UNITED STATES PATENT AND TRADEMARK OFFICE

APPLICATION NO.	FILING DATE	FIRST NAMED INVENTOR	ATTORNEY DOCKET NO.	CONFIRMATION NO.
09/886,450	06/21/2001	Shi-Chang Wooh	MIT-117J	5772

Office Action Summary

DETAILED ACTION

FIG. 4

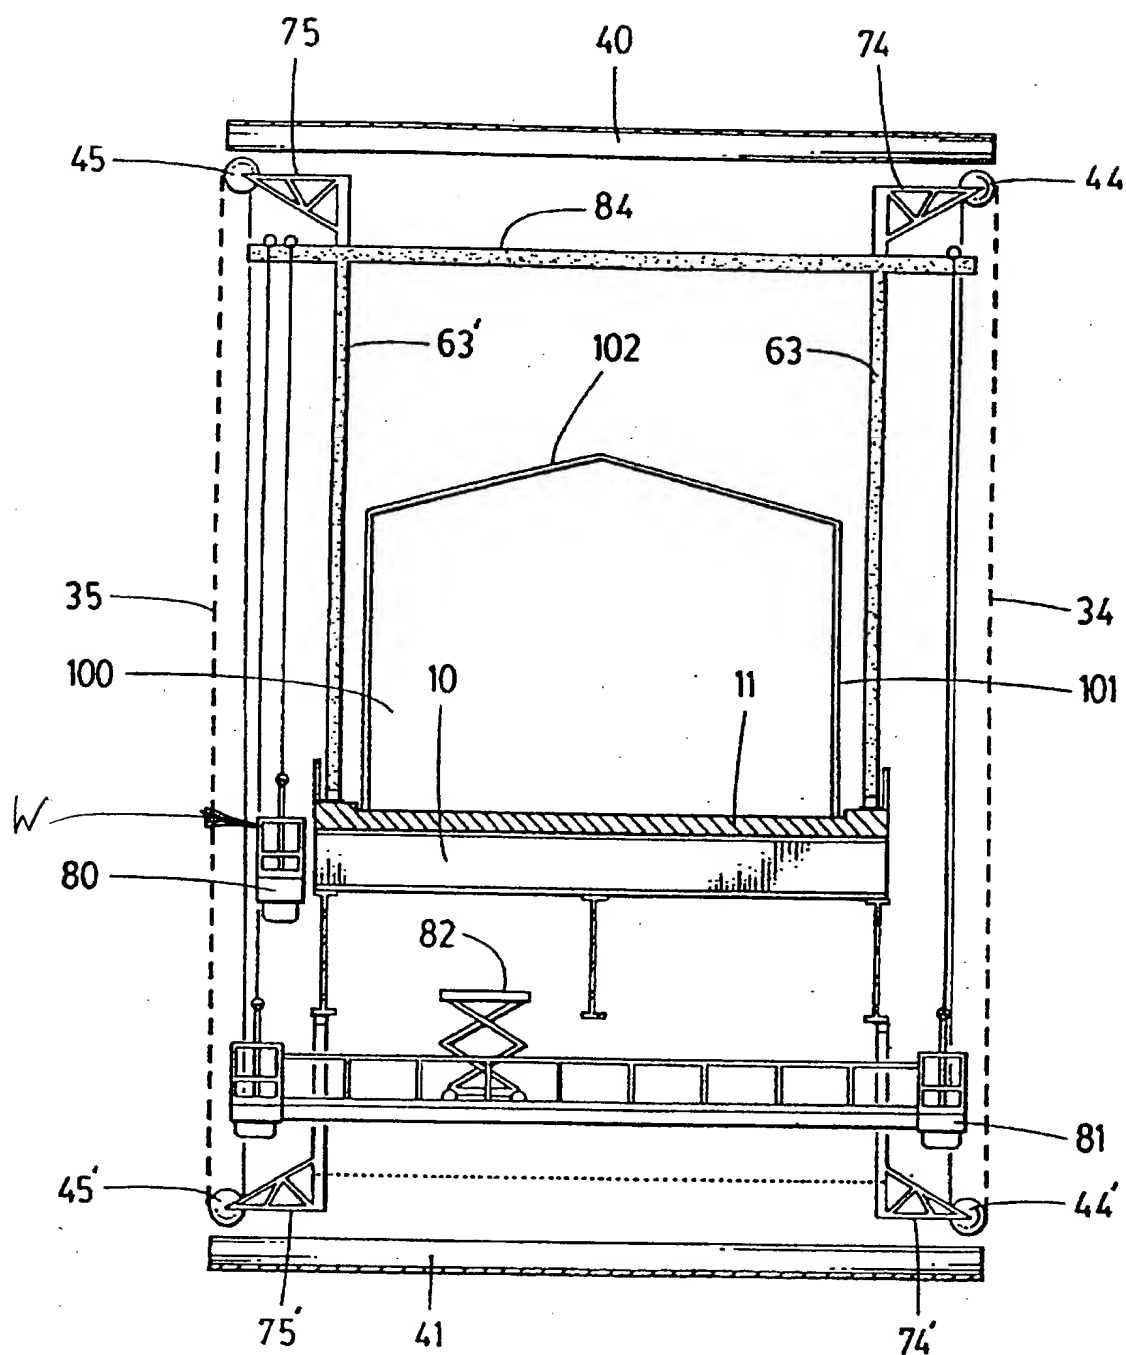
1. The text of those sections of Title 35, U.S. Code not included in this action can be found in a prior Office action.
2. Claims 1-3,14-16 stand and claims 5,9,10,12 and 18 are rejected under 35 U.S.C. 102(b) as being anticipated by US Patent #5,634,528 to WATTS et al. WATTS et al. discloses a building construction including a support structure (63, 63'), a support beam (84), at least one enclosure cell (80), and at least one tension member (83); wherein the tension member (83) suspends the enclosure (80) from the support beam (84), column 4, lines 26-31. In reference to claims 2 and 3, WATTS et al. discloses a support structure in the form of at least two columns (63, 63'). Regarding claim 5, the support beam (84) is a linear beam, see figure 2 and 4. In reference to claims 9 and 10, the support beam (84) also includes a number of tension members in the form of cable elements (83) that are used to suspend the enclosure cell (80). Regarding claim 12, the enclosure cell (80) includes a wall (W), see the marked attachment, and a floor, column 4, lines 47-51.

In reference to claim 14, WATTS et al. discloses the method of using tension support members including the steps of providing a support structure (63, 63'); installing a support beam (84); providing at least one enclosure cell (80); and suspending the enclosure cell (80) with a tension member (83) from the support beam (84), column 4, lines 26-31. Regarding claim 15, WATTS et al. further discloses suspending several enclosures (80) from the support beam (84), see figures 2-5. In reference to claim 16, the support structure (63, 63') include at least two columns. Regarding claim 18, the support beam (84) is a linear beam, see figure 2 and 4.
